Douglas West Wind Farm Extension

Section 36 Gatecheck Report

March 2019

Figure 2

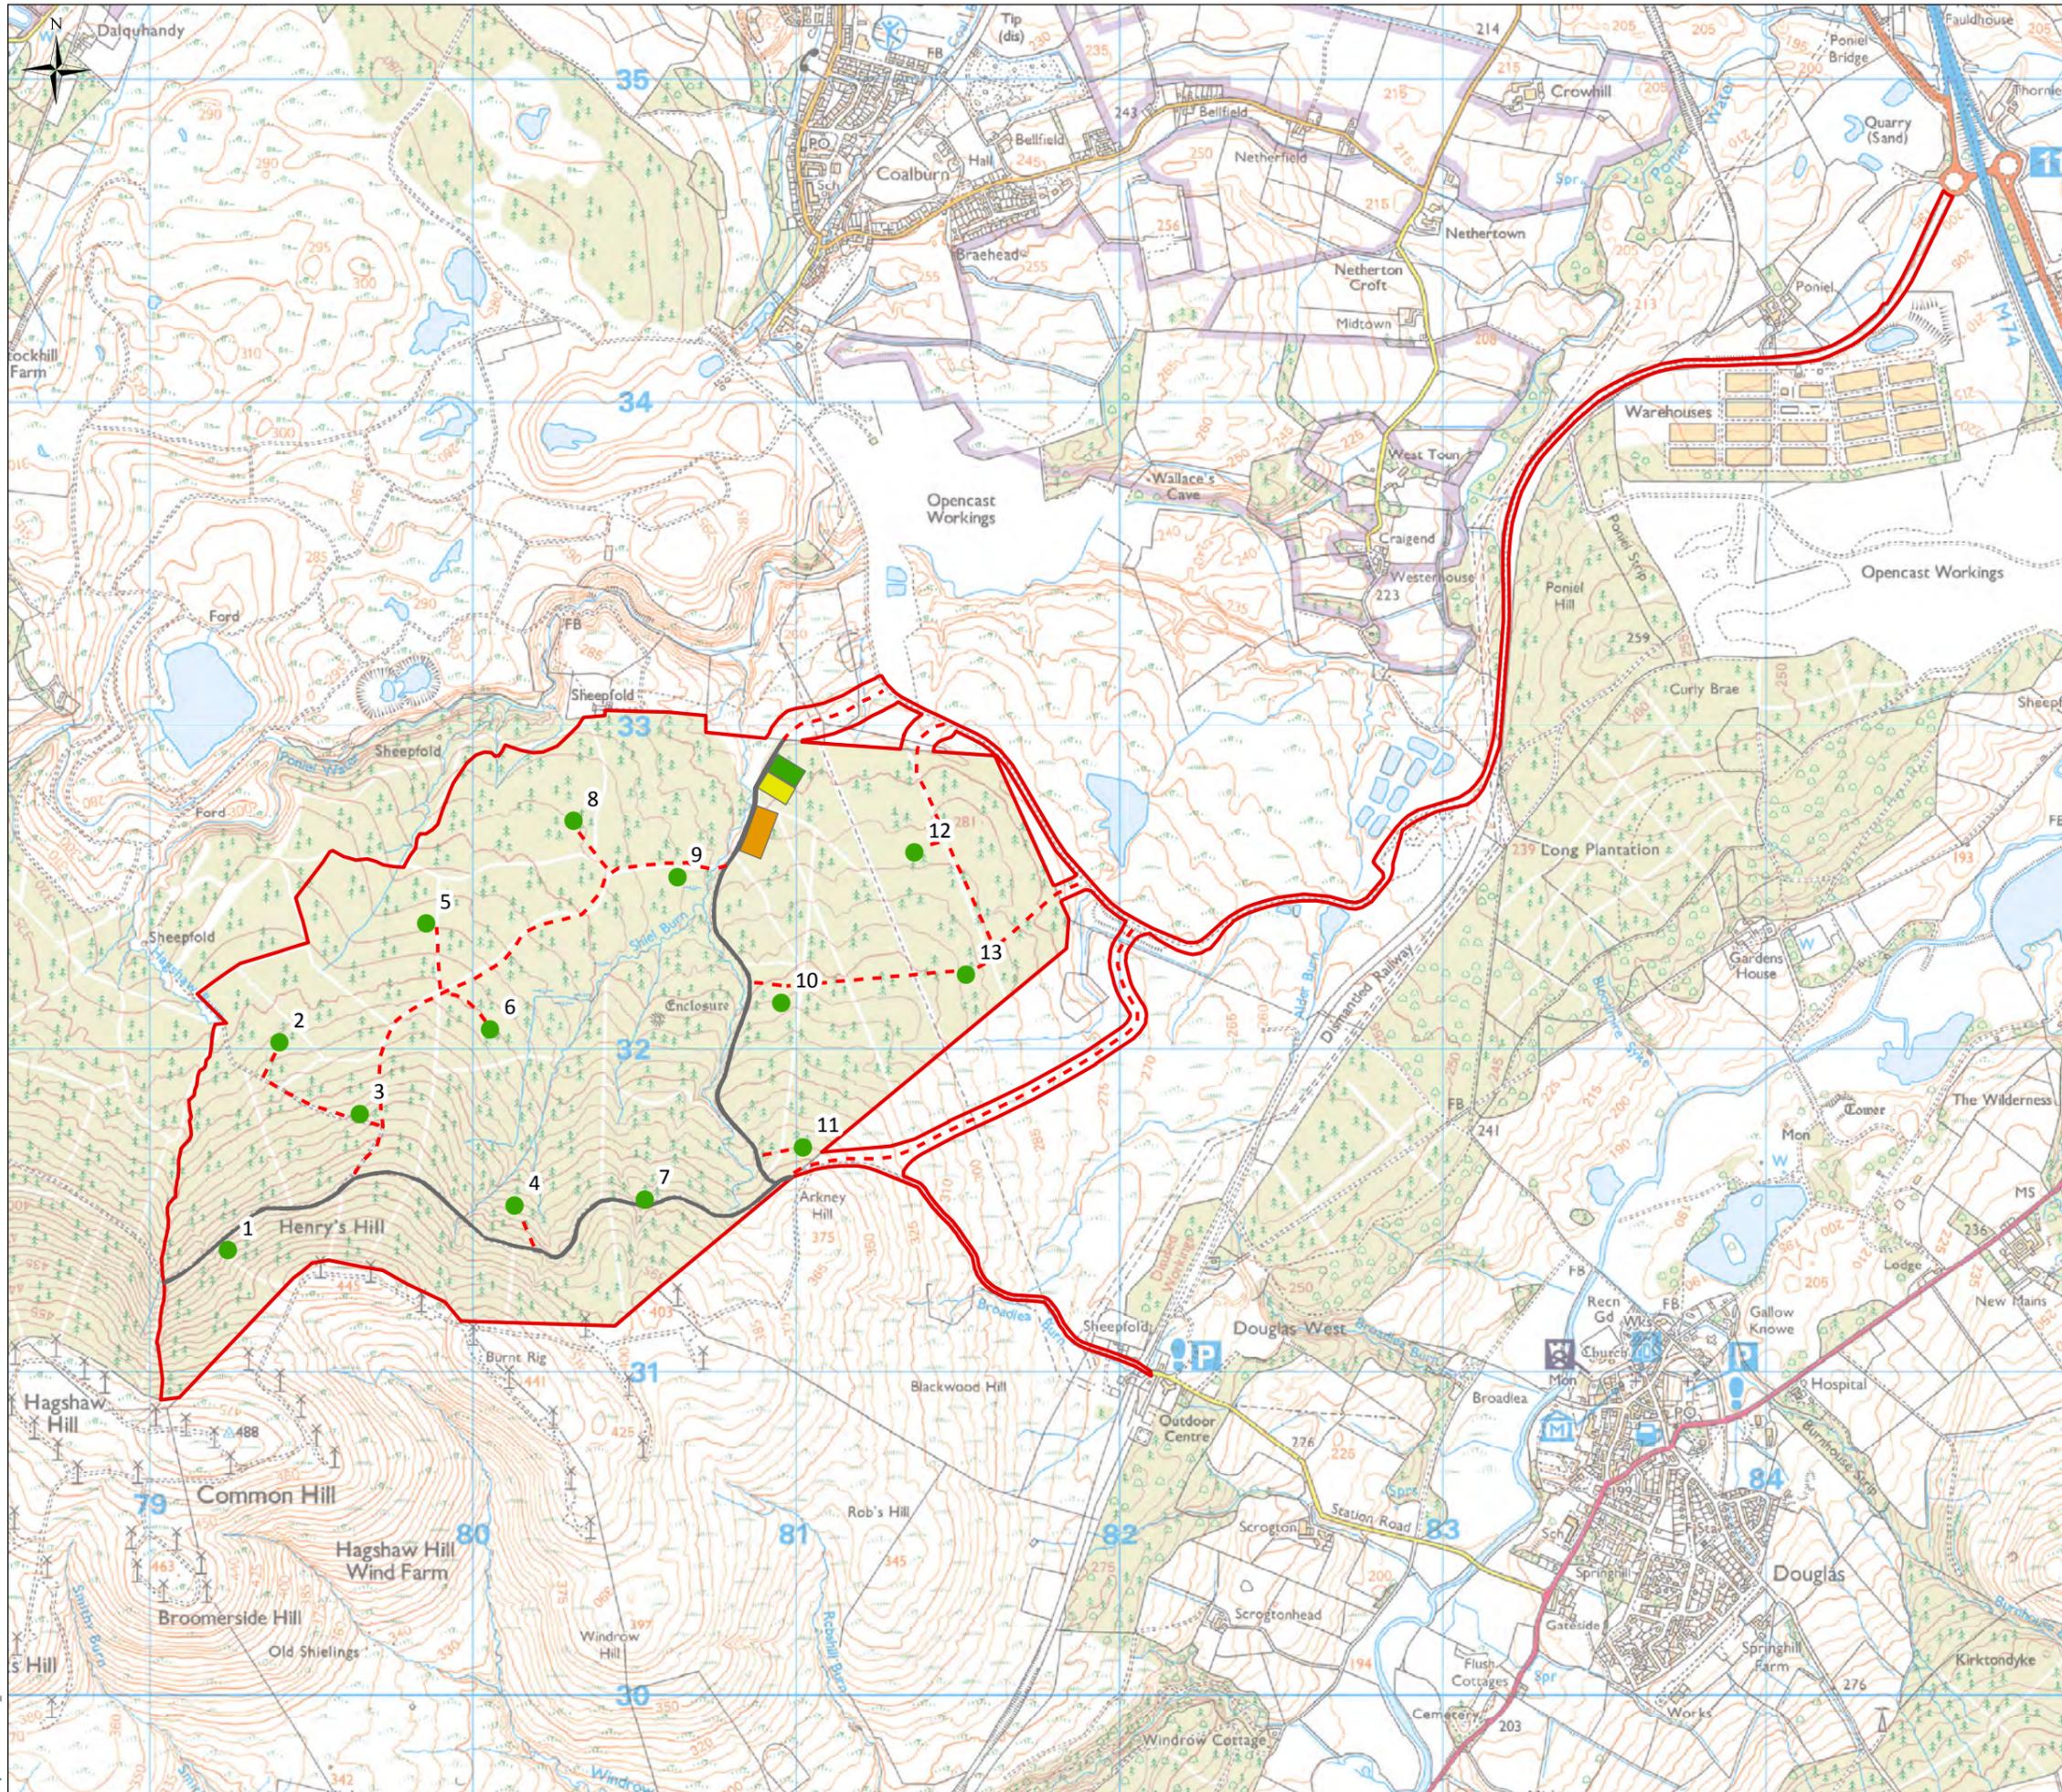
2.1.1 In November 2018, as part of the EIA Scoping Report, the Applicant submitted an indicative turbine layout for the Proposed Development of 13 turbines (refer to Figure 2).

Design Iteration	No. Turbines	Date	Description
A (Figure 2)	13	November 2018	Original scoping report design maximising capacity on the site and maximal use of existing on site infrastructure.
B (Figure 3)	13	January 2019	Turbines (T4, T7, T11 and T13) moved to reflect environmental constraints and forestry operations. Infrastructure including the temporary site compound, lay-down areas and access tracks moved.
C (Figure 4)	13	January 2019	Turbines moved following comments from Landowner including the movement of T6 to ensure appropriate turbine spacing. Site boundary rationalised following legal agreements. Substation and laydown areas moved to the entrance of the main body of the site to minimise impact on existing forestry and to ensure efficient construction.
